VISIONING UMCH

PUBLIC WORKSHOP COMMENTS

Mixed-Use 1

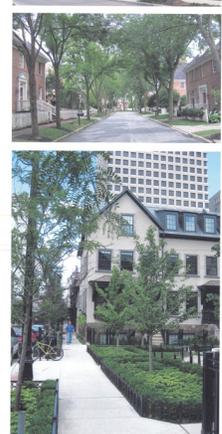
- Connection to Larrimer is problematic, already many accidents here
- Central Oval: Needs access roads, could be more centrally located, could fit a splash feature
- Too much office competing with the Wilson Bridge Road Corridor, and too far from highway
- This is the most appealing option, good mix of office and retail with residential and greenspace
- Extension of Hayhurst into the site as shown is the least disruptive way to provide access from the north
- Housing is too dense; apartments will hurt schools and property values
- Green space seems to be more for resident use rather than for the larger community
- Residential along Longfellow makes sense
- The new road network segregates residential from busy streets, and remains connected for walkability
